Sydney Metro West Westmead to The Bays and Sydney CBD

Submissions Report
Concept and Stage 1
2020

Figure 2-1: Location of receiver that has been reclassified

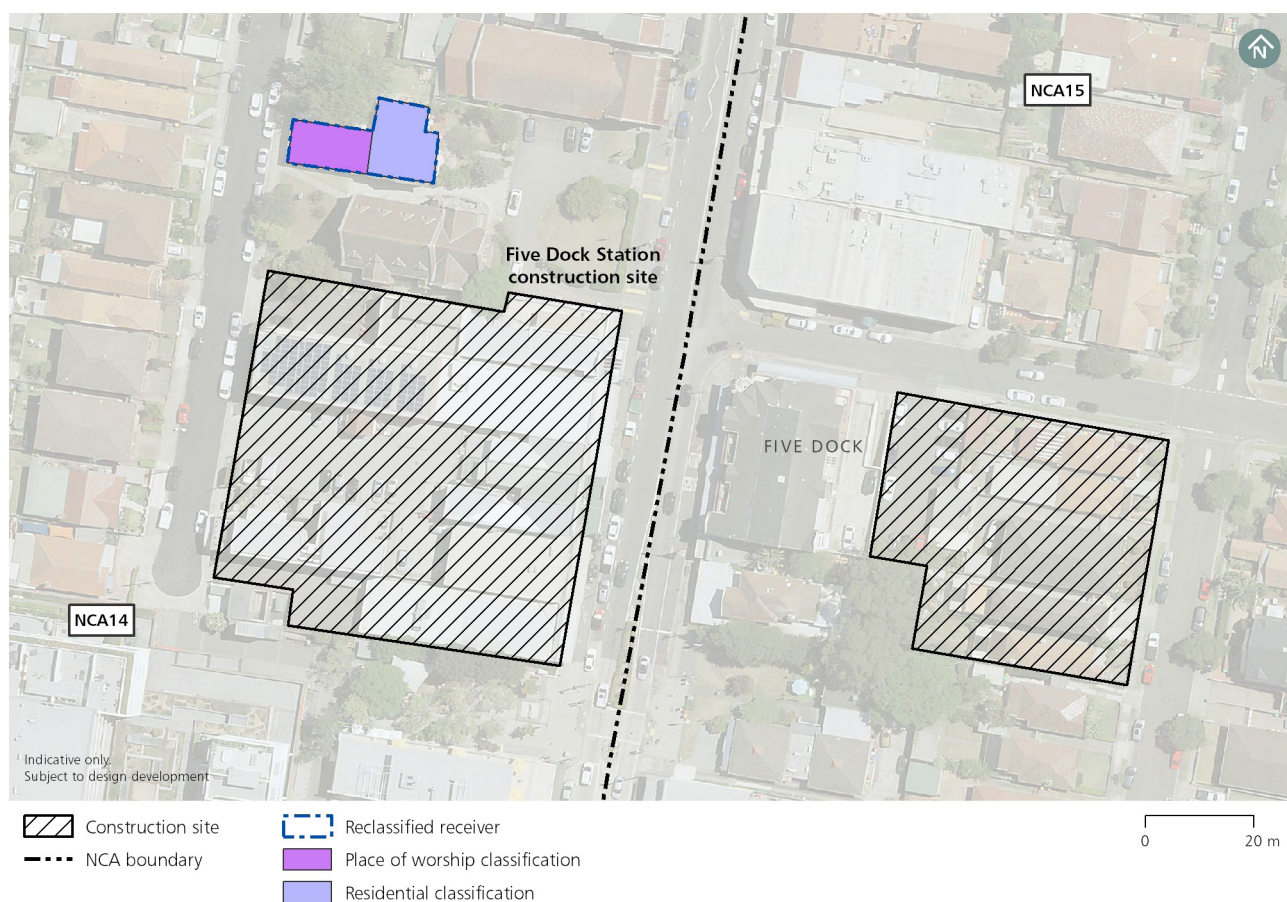
Figure 11-28 of the Environmental Impact Statement shows the St Alban's Church as a place of worship near the Five Dock Station construction site as part of Noise Catchment Area 14 (NCA14). Section 11.3 of the Environmental Impact Statement describes the noise impacts predicted for NCA14 from the Five Dock Station construction site.

Since exhibition of the Environmental Impact Statement this receiver has been identified as a mixed-use receiver, comprising a parish centre at the western end and a residential clergy house that serves as the residence for the minister at the eastern end, as shown in Figure 2-1.

Figure 2-2: Amended The Bays Station construction site layout

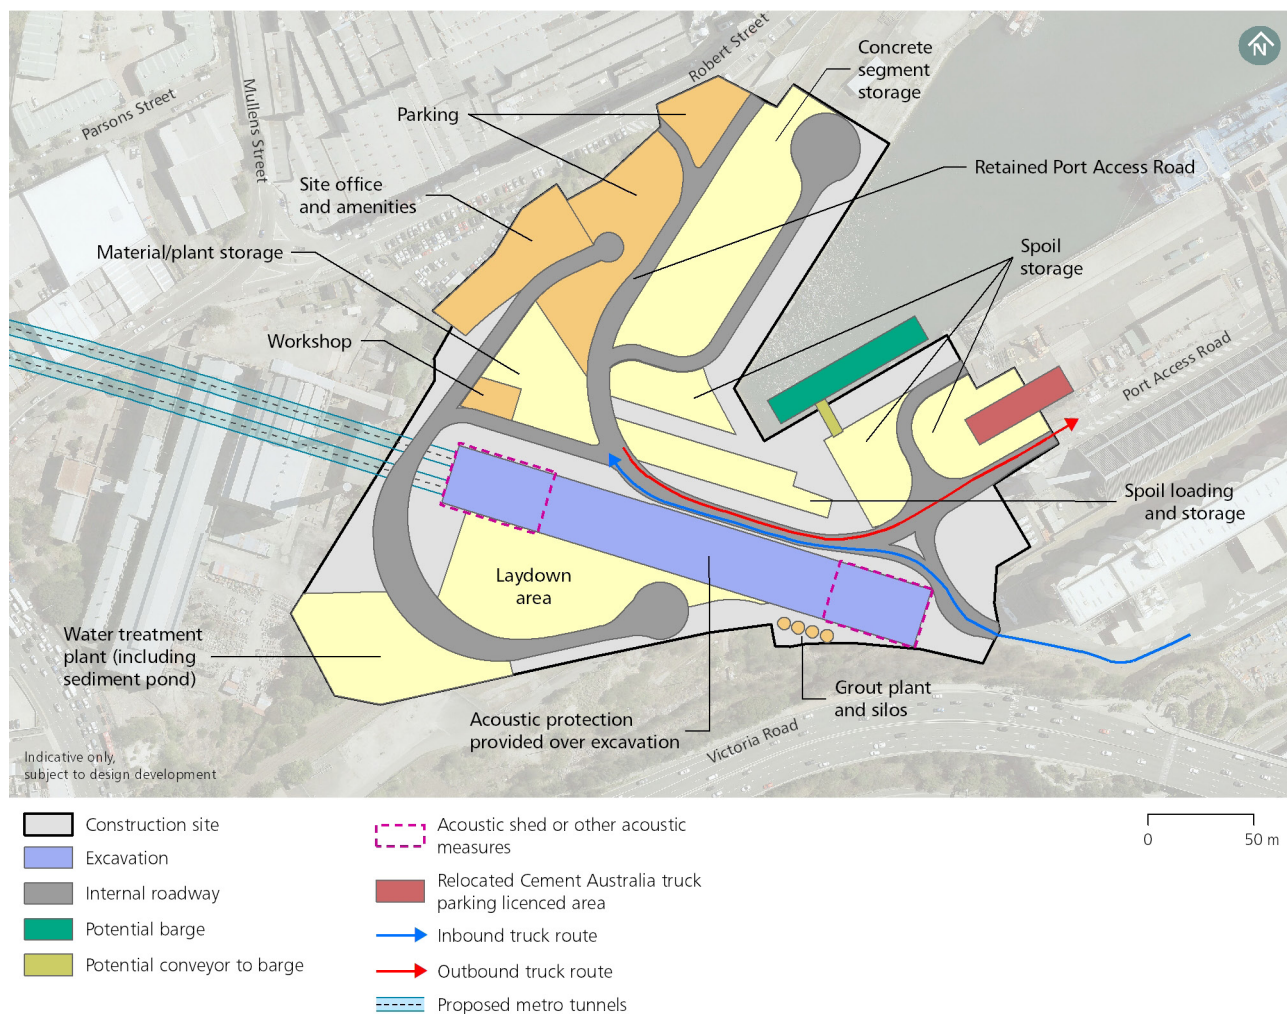
The use of water transport for movement of spoil was raised in the Inner West Council submission while community submissions identified concerns and comments regarding heavy vehicle movements and queuing near The Bays Station construction site. In response, the transport of tunnel spoil by barges has been further considered. While the transport of spoil via trucks as described in the Environmental Impact Statement remains the primary method of spoil transport, this section provides additional information regarding the barging option, for spoil generated from The Bays Station construction site.

Figure 9-30 in the Environmental Impact Statement shows the location of a potential conveyor to a barge and is shown in Figure 2-2. Figure 2-2 also shows an amended construction site layout as described in the *Sydney Metro West Westmead to The Bays and Sydney CBD – Amendment Report* (Sydney Metro, 2020b) (the Amendment Report).
